**ADMINISTRATIVE APPROVAL (ASV) ADD2008-00078**

**ADMINISTRATIVE APPROVAL  
LEE COUNTY, FLORIDA**

WHEREAS, Boyd Hippenstiel/Federal Heath Sign Company, in reference to Super Target at Coconut Point, filed an application for administrative approval of a deviation for signage for development of property located at 8040 Mediterranean Drive, described more particularly as:

### ADMINISTRATIVE AMENDMENT (PD) ADD2007-00192

FRONT ELEVATION "PARTIAL"

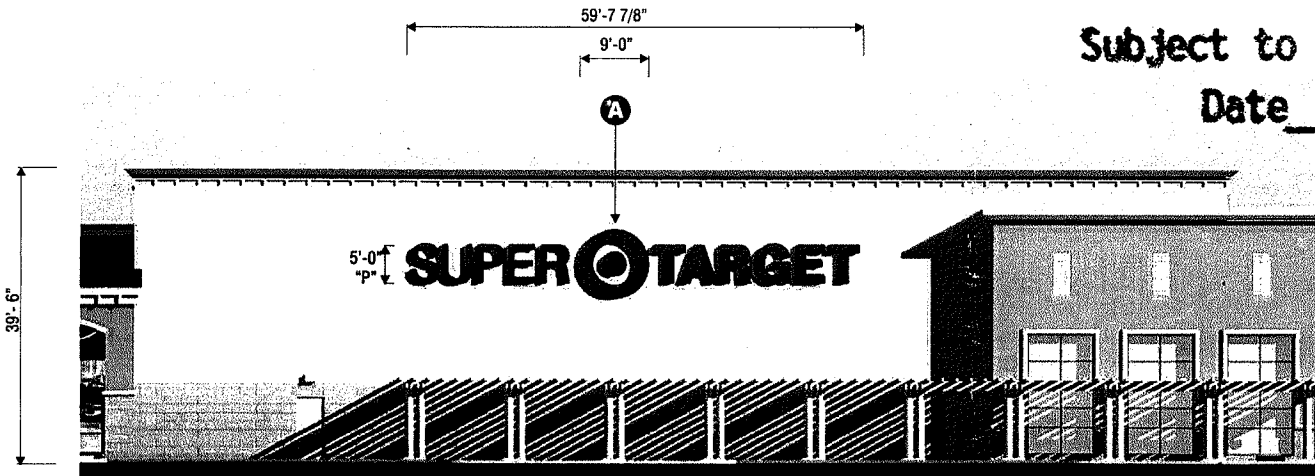
- a. Front elevation - Signage will total 684.5 square feet as follows:
  1. "Super Target" with bulls eye consisting of a total of 537 square feet;
  2. "Grocery" consisting of a total of 43 square feet (existing);
  3. "Pharmacy" consisting of a total of 35 square feet (existing);
  4. "Garden Center" consisting of a total of 69.5 square feet (existing)  
(an increase of 202.25 square feet)
- b. Left elevation - "Super Target" with bulls eye consisting of 537 square feet;  
(an increase of 202.25 square feet)
- c. Right elevation - "Super Target" with bulls eye consisting of 537 square feet;  
(an increase of 202.25 square feet)

1. **Total sign square footage located on the front, left and right elevations must not exceed 1,758.50 square feet as follows:**
2. **Front elevation - Signage totaling 684.5 square feet as follows:**
  - a.
    1. **"Super Target" (includes the words "Super Target" and bulls eye logo) consisting of a total of 537 square feet;**
    2. **"Grocery" consisting of a total of 43 square feet (existing);**
    3. **"Pharmacy" consisting of a total of 35 square feet (existing);**
    4. **"Garden Center" consisting of a total of 69.5 square feet (existing);**
  - b. **Left elevation - "Super Target" (includes the words "Super Target" and bulls eye logo) consisting of a total of 537 square feet.**
  - c. **Right elevation - "Super Target" (includes the words "Super Target" and bulls eye logo) consisting of a total of 537 square feet.**

**108" BULLSEYE & 60" SUPER TARGET**  
 QUANTITY: THREE (3) REQUIRED

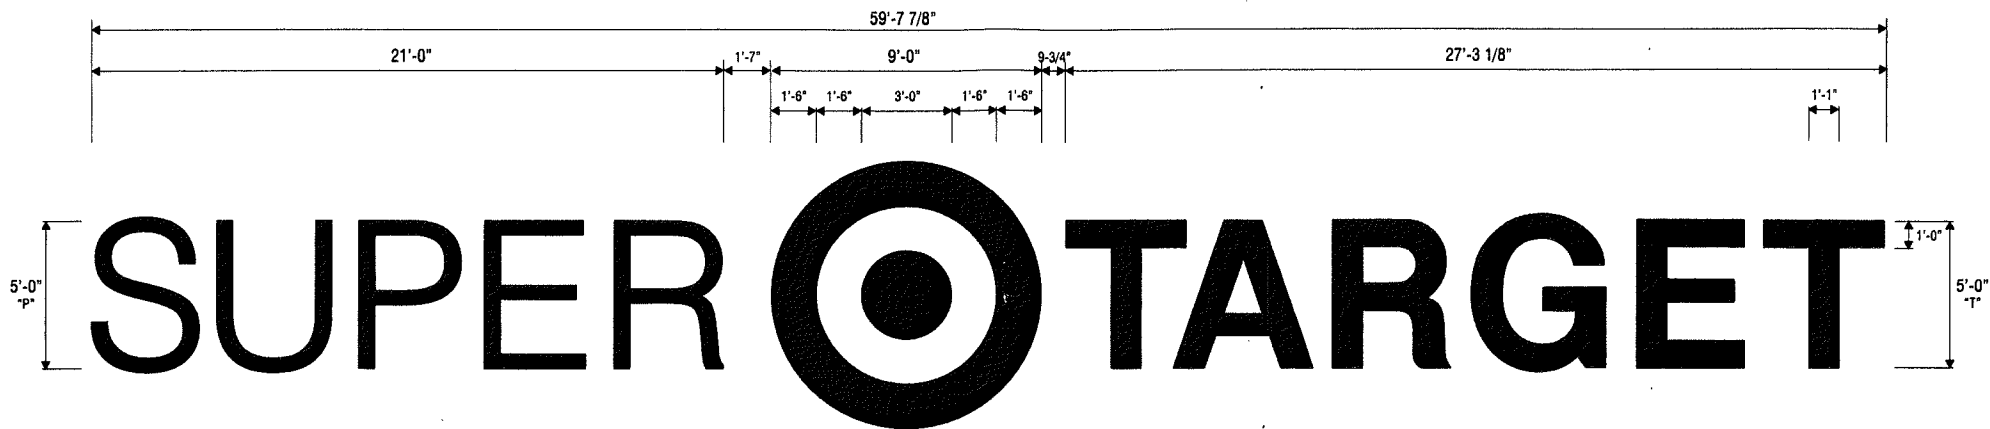
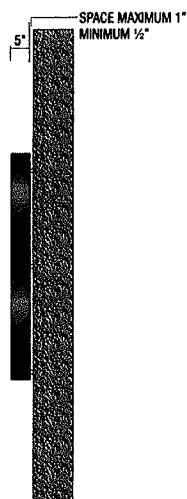
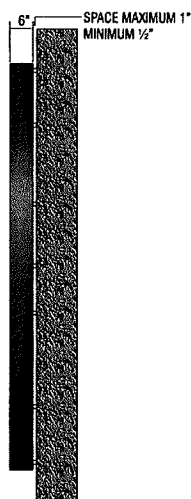
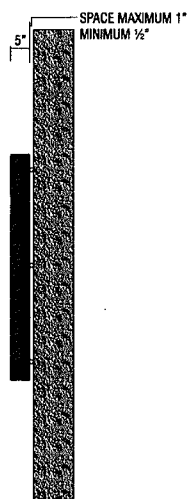
Therefore, the subject signage, consisting of the words "Super", "Target" and the bulls eye logo, is measured as one unit totaling 537 square feet, in lieu of three individual sign components totaling 334.75 square feet; and
